SERVICE BULLETIN

TS-830S

#840R

SUBJECT: TS-830S Frequency Shift

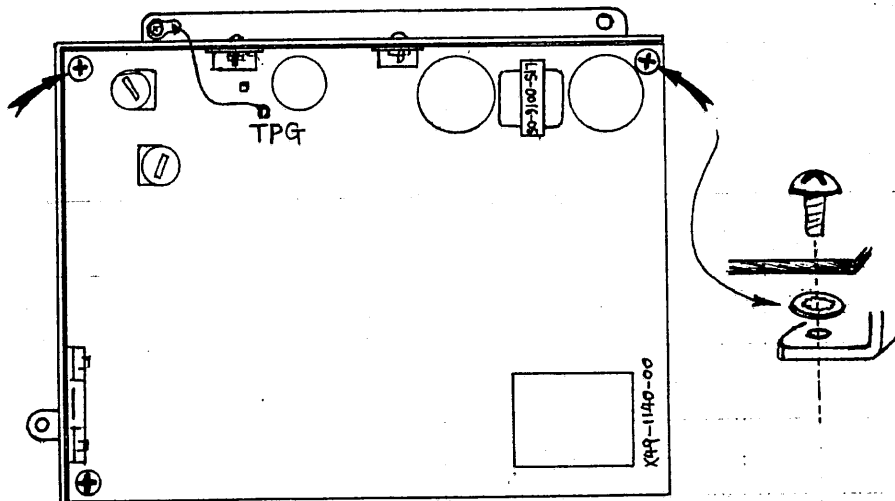
Some users may report an intermittent shift in display and operating frequency. This may typically be a 1 to 4 KHz random shift. Cause will be a loose grounding screw on the AF-AVR unit heat sink.

On the AF-AVR unit X49-1140-00, there are three self-tapping screws holding the aluminum heat sink to the PCB. These also supply the ground connection to that section of the board. Between the heat sink and PCB foil, add a tooth-lock washer N17-1030-41 at the two self-tapping screws shown. (The remaining screw already has a tooth-lock washer.)

When replacing the board to the chassis, add a solder lug E23-0420-05 to the heat sink mounting screw as shown, and tighten all screws for this board. Solder an insulated lead between the TPG (Test Point Ground) wrap post adjacent to C81, and the added solder lug.

1. Remove the top cover (8 screws) and unplug the speaker.
2. Remove the bottom cover (8 screws).
3. Remove 5 screws holding the AF-AVR unit and swing the board over. Leads do not have to be unplugged.
4. Add two tooth-lock washers as shown.
5. Replace the circuit board and heat sink to the chassis, adding the solder lug as shown.
6. Solder a jumper between the TPG wrap post and the added solder lug.
7. Replace the top and bottom covers.
